Amendments to the Drawings:

REMARKS/ARGUMENTS

1-2. DRAWING OBJECTION FOR FIGS. 7A-7B:

FIG. 7B

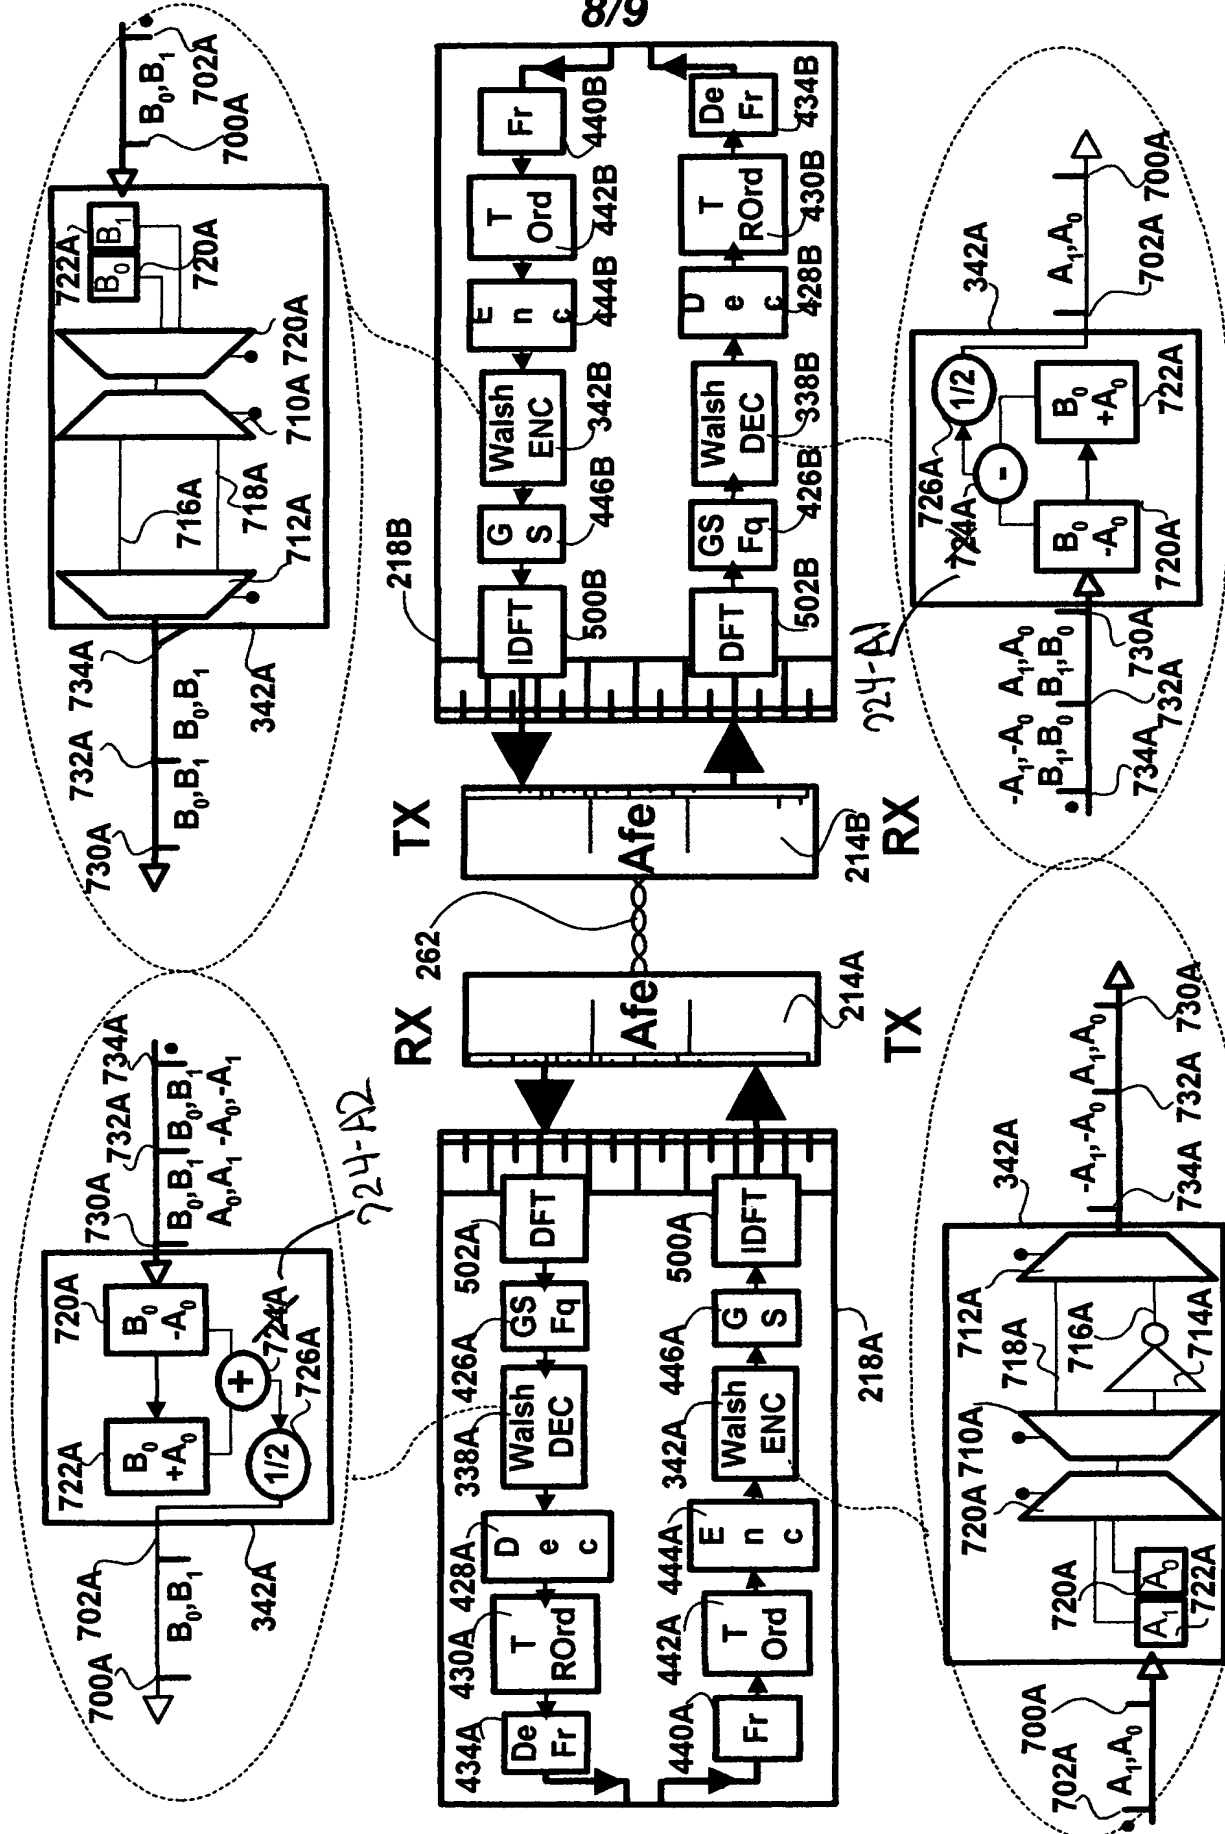
The drawings, specifically Figures 7A-7B, were objected to because reference number 724A was used to designate both an adder and a subtractor.

The operation of the Walsh decoders 338A-338B shown in FIGS. 7A-7B has in common with all Walsh decoders the combination of a codeword with a received signal stream. The embodiment shown in FIGS. 7A-7B sets forth detailed decoder hardware operable in the case of FIG. 7A on the tones within a symbol and in the case of FIG. 7B on successive symbols to decode same thereby removing the redundancy in the frequency or time domain redundancy there from. The Walsh codeword used to encode and decode the upstream communication channel is orthogonal to the Walsh codeword used to encode and decode the downstream communication channel, e.g. (+1,-1) and (+1,+1).

The attached sheets of drawings include changes to Figs. 7A and 7B. These sheets replace the original sheets including Figs 7A and 7B.

The Applicant has amended to correspond with the specification to correspond with the drawings in which subtractor 724A in the Walsh decoder 338A of FIGS. 7A-7B and the adder 724A in the Walsh decoder 338B of FIGS. 7A-7B are appropriately referred to in the specification and assigned revised reference numbers in the attached replacement sheets and the amended specification. The Applicant therefore respectfully requests that this objection be withdrawn.
